## Appendix to Installation Instructions Model HUB-4

Communication Card for NCCNTWAN

This errata sheet applies to the HUB-4 Installation Instructions, P/N 315-099458.

Figure 1 – Location of S2 on HUB-4, Main-2

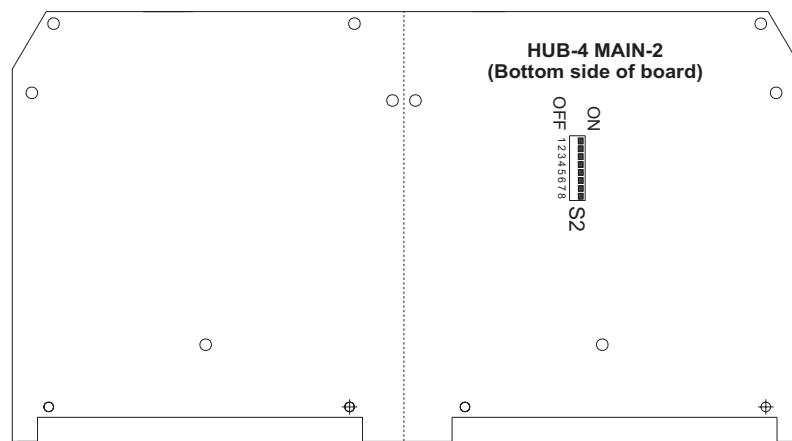
1. **Page 3. The setting of the switches on HUB-4, Main-2 Board (Switch S-2) should read as follows:**

All switches on the HUB-4, Main-2 Board (Switch S2) must be set in the ON position. (Refer to Figure 1.)
